CITY OF ALBUQUERQUE

**RE: Lot 13P1 Block 9B Unit 3
6340 Pima NW
Grading and Drainage Plan
Engineers Stamp Date 12/1/17 (E10D041)**

Based upon the information provided in your submittal received 10/19/17, this plan is approved for Grading Permit.

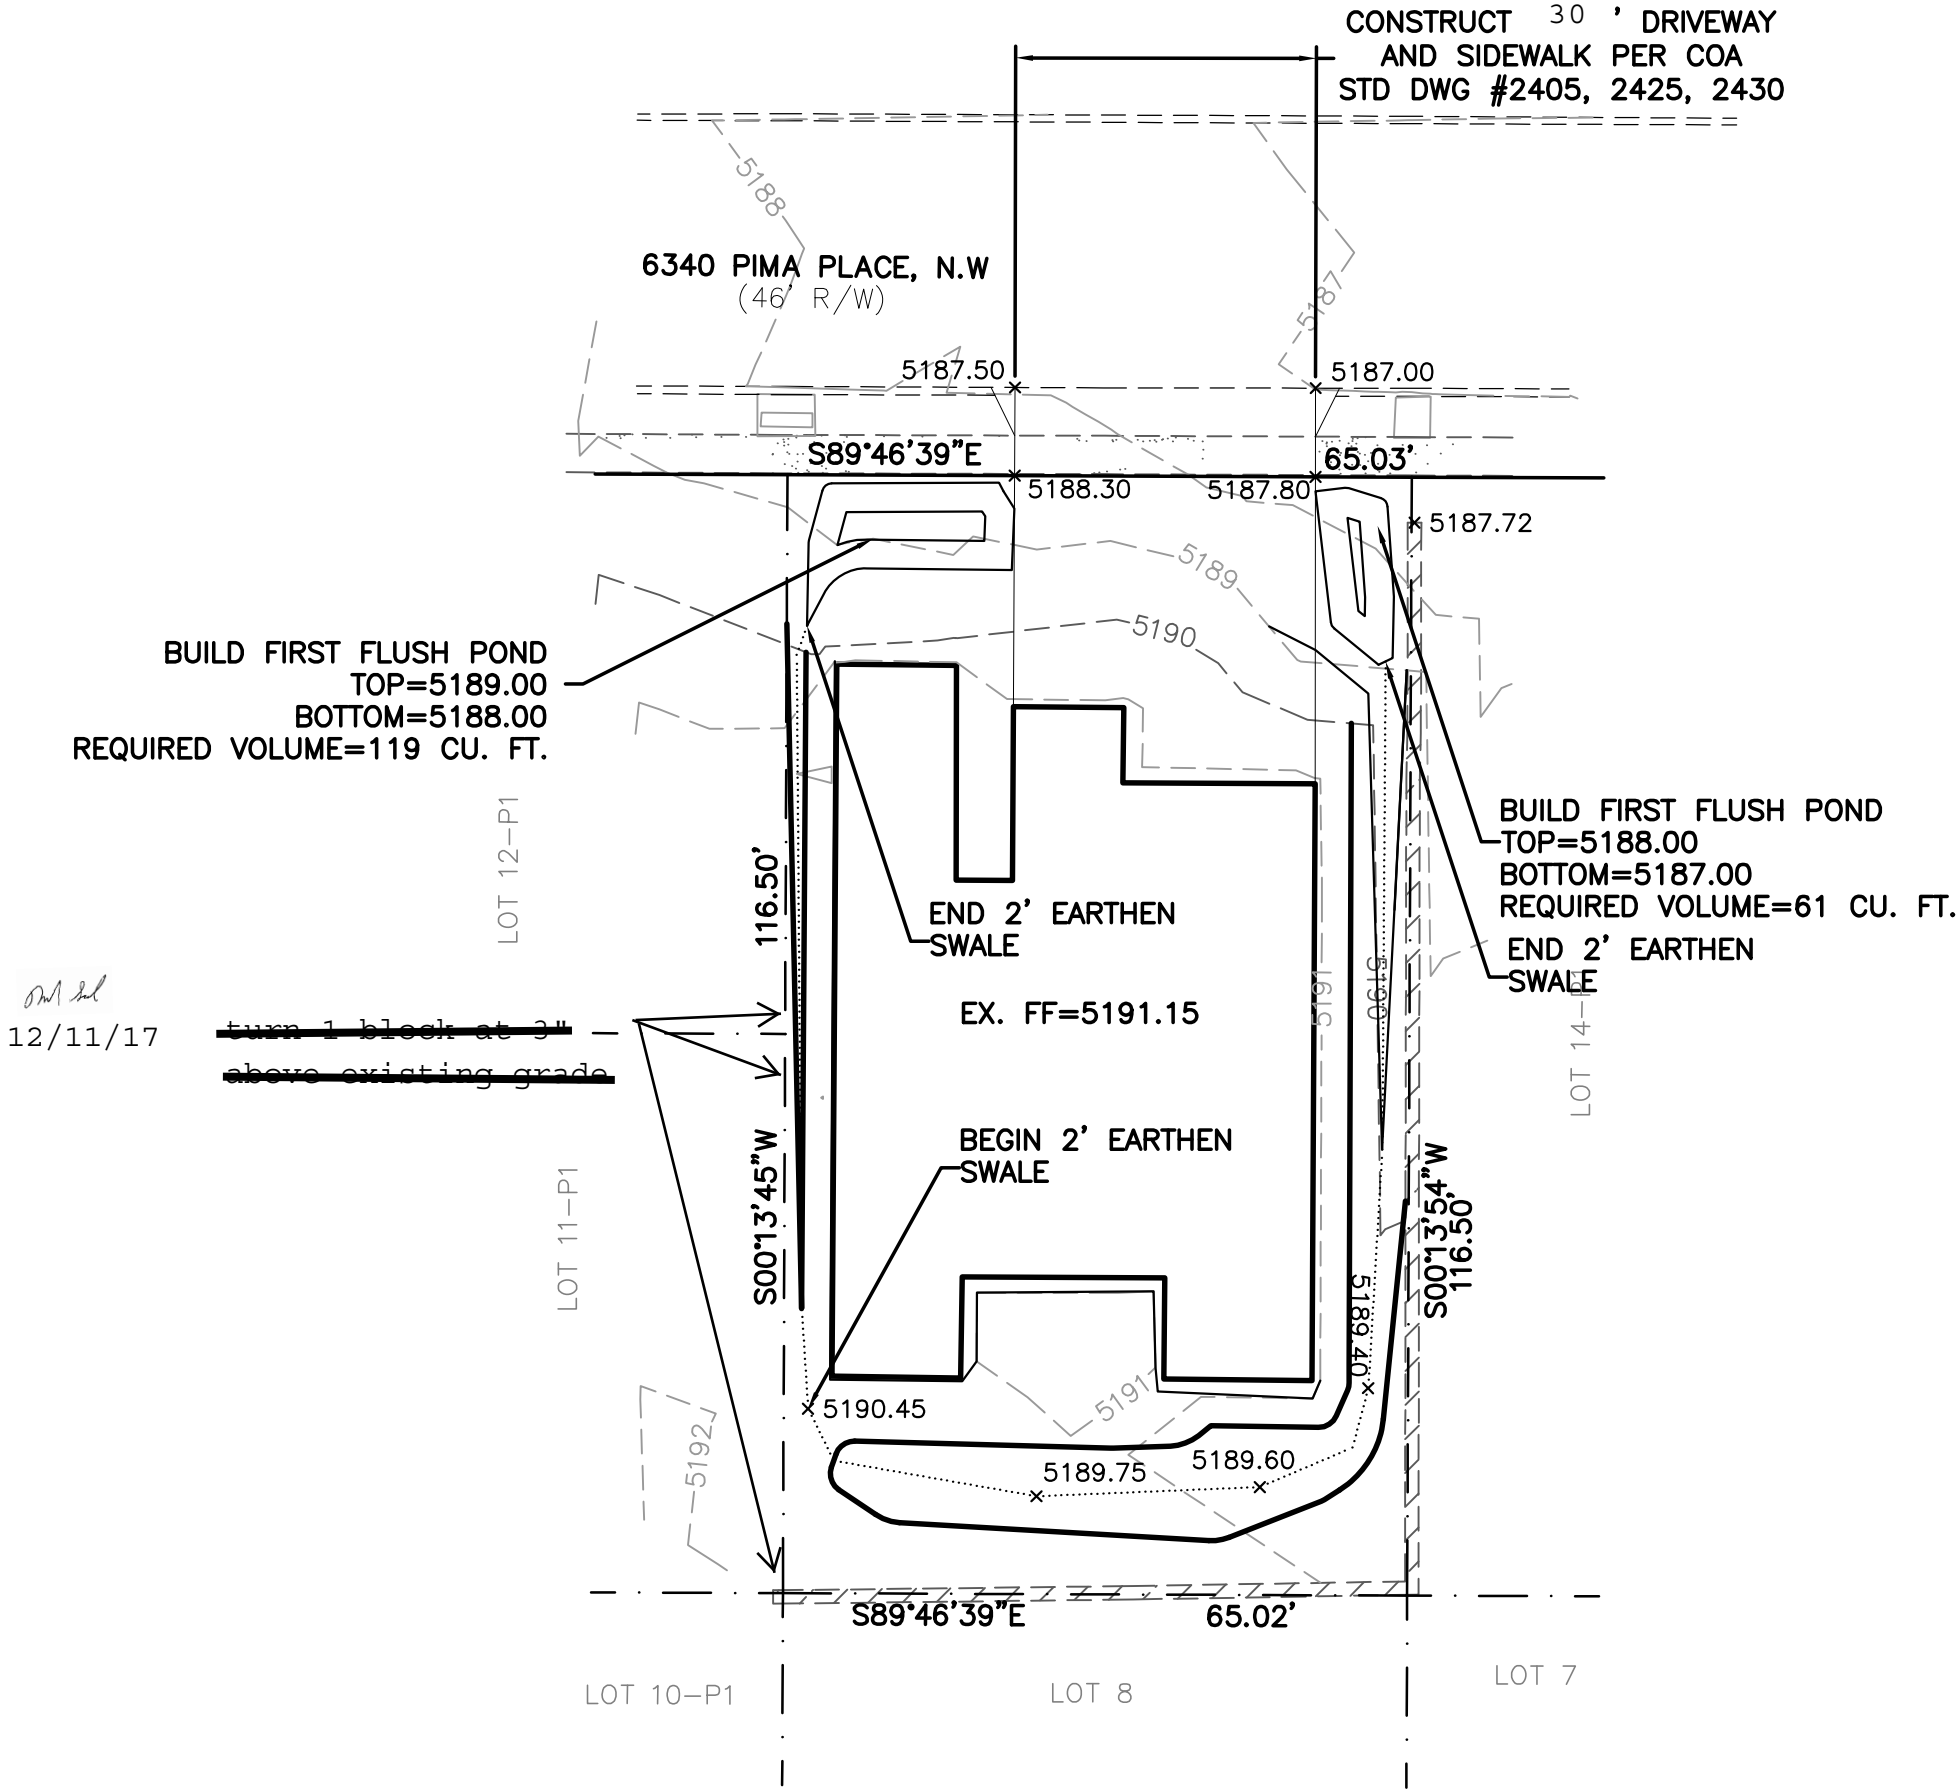
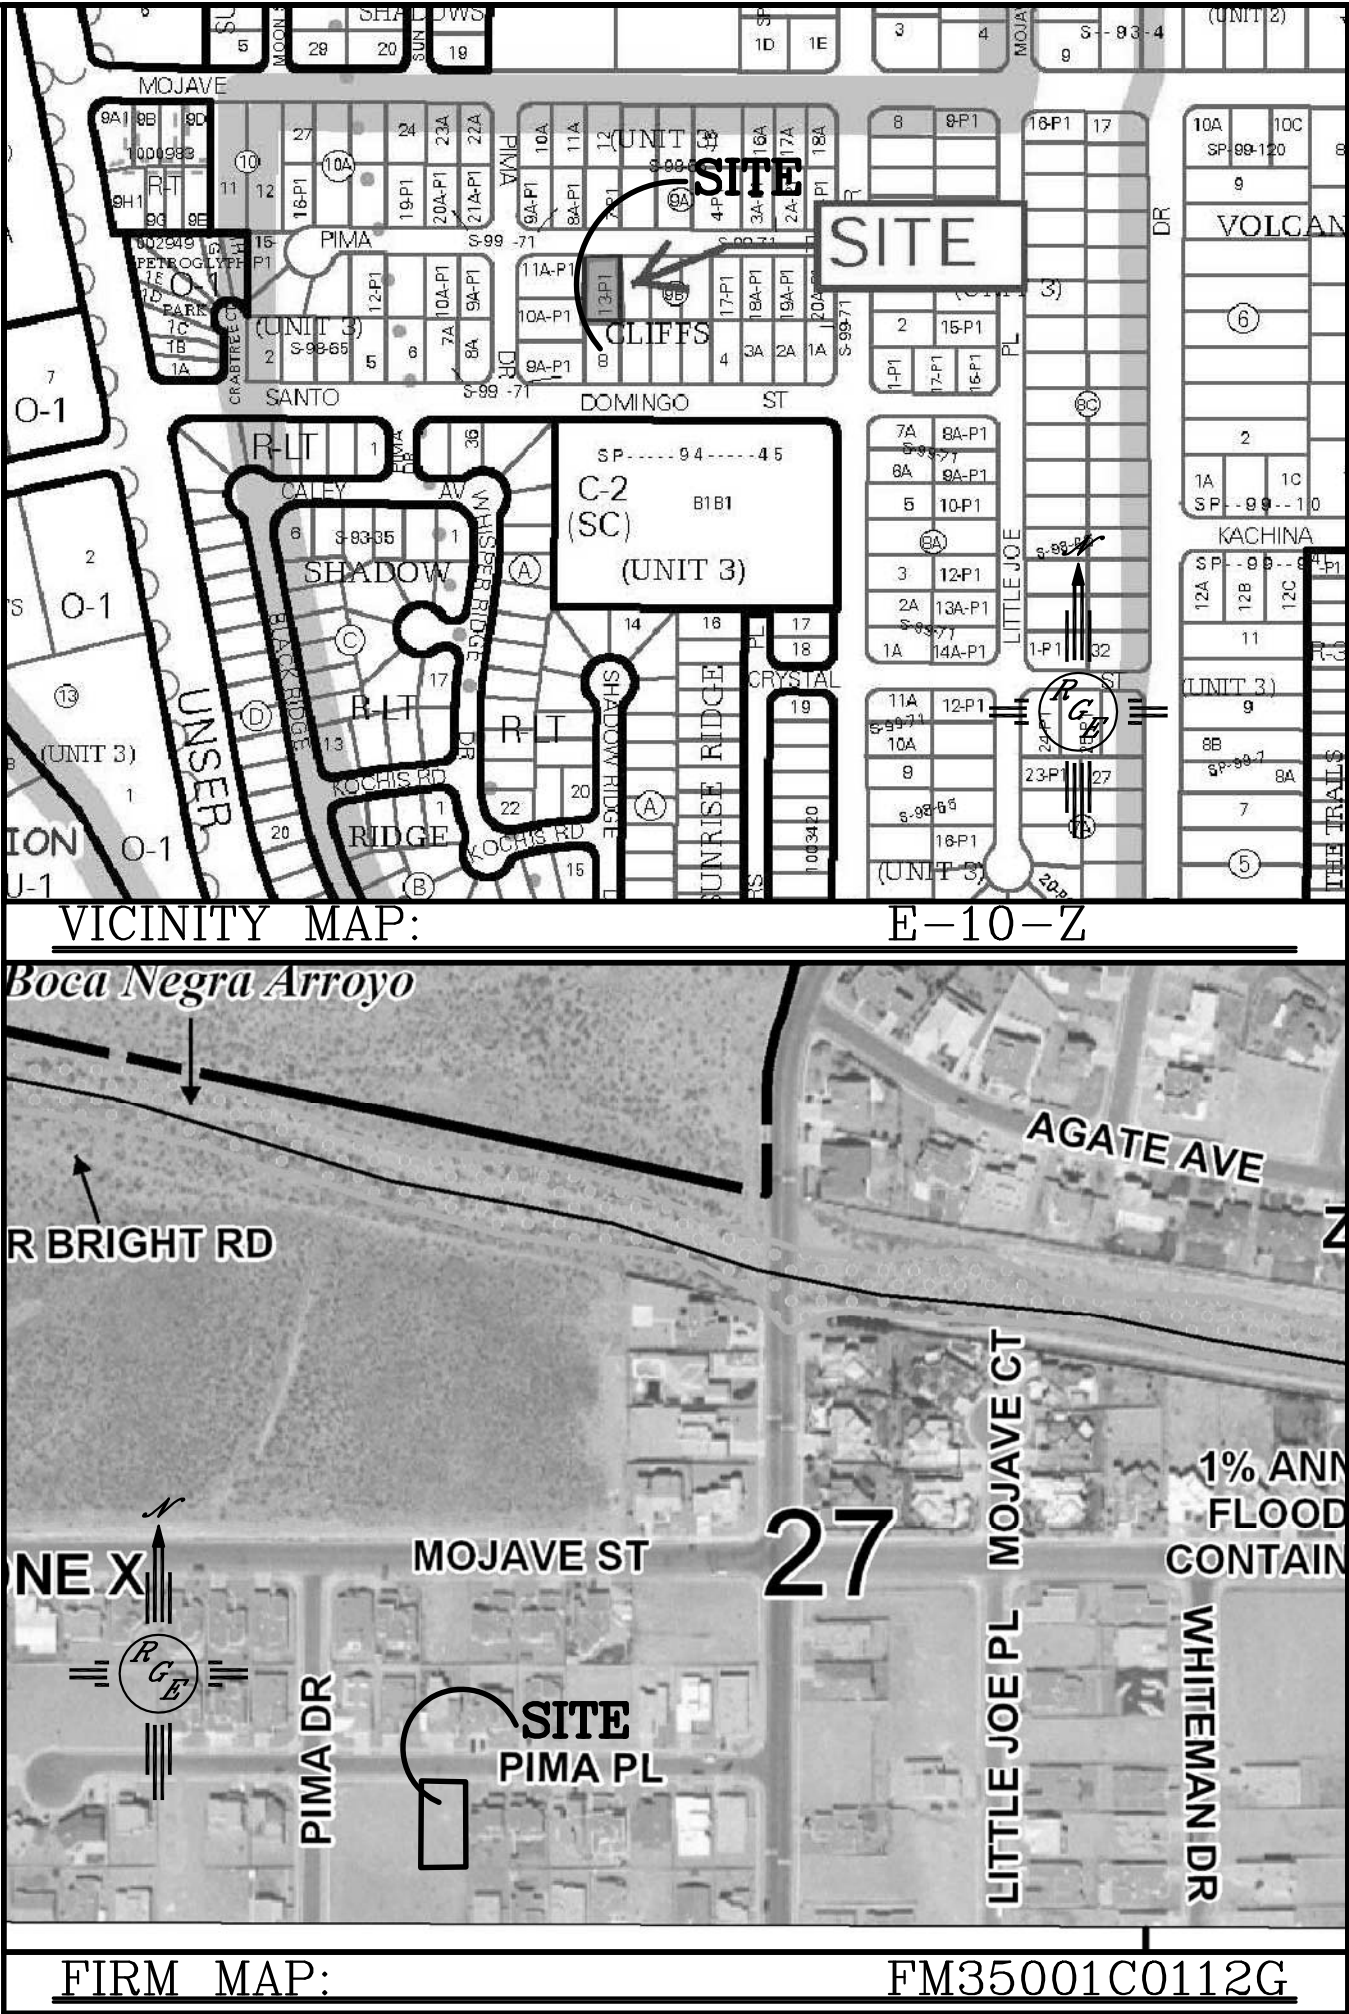
Reiterate to the Owner/Contractor that a separate permit for a garden/retaining wall must be obtained, with the approved G&D plan and Pad Certification.

Prior to Certificate of Occupancy release, Engineer Certification per the DPM checklist of this plan will be required.
